XAUI Electrical Results

M1. Receive eye

M2. Compliance Channel

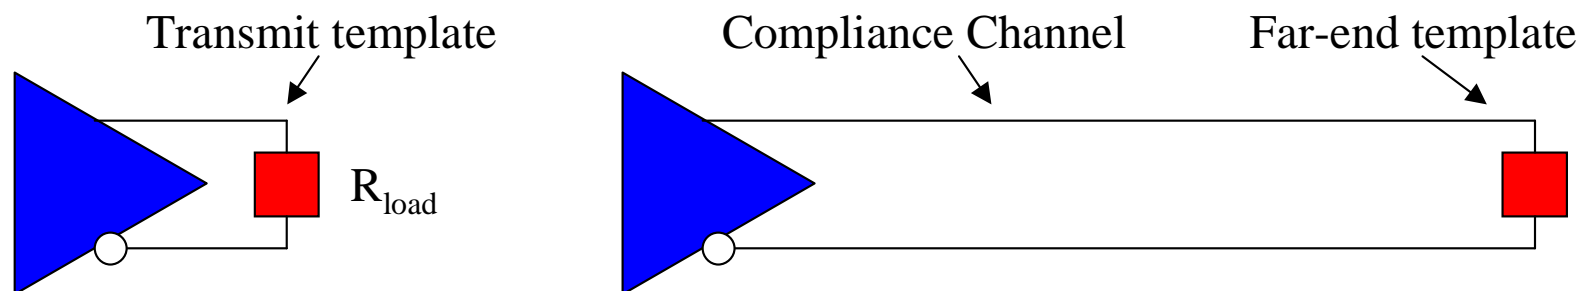
Specify a compliance channel as follows.

1. Specify the upper bound on S_{21} magnitude.
2. Specify the minimum ISI loss.
3. Specify the maximum group delay.
4. Specify the channel impedance.

M4. Maximum Amplitude

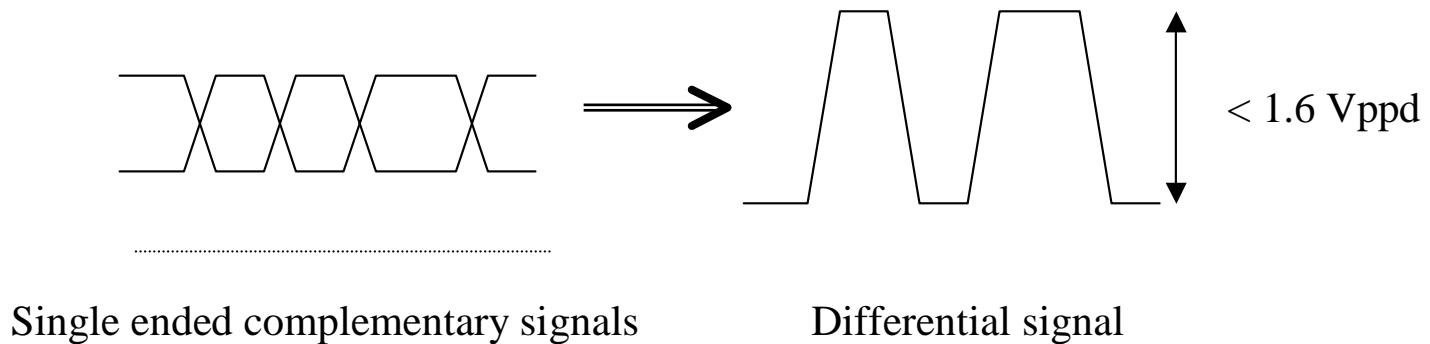
Change the maximum driver output amplitude and receive input amplitude from 1.0 V to 1.6V peak-to-peak differential.
